FIELD SERVICE CAMPAIGN – 17104

Auto Start-Stop – PTO Parameter Change

LT™ Series with Cummins® X15

Figure 2. Parameters in SAE J1939 Multiplexing Group

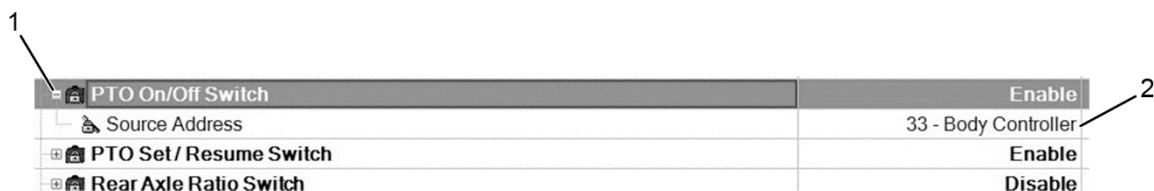
On certain LT™ Series models, the Auto Start-Stop function may have not been programmed in the Cummins ECM and, when activated, engine idle speed does not increase and engine shuts down after 5 minutes of idle.

1. PTO On / Off Switch
 2. 33 - Body Controller
8. Locate and expand PTO ON / OFF SWITCH (Figure 2, Item 1).
 9. Set PTO ON / OFF SWITCH to ENABLE.
 10. Confirm that SOURCE ADDRESS is 33-BODY CONTROLLER (Figure 2, Item 2).
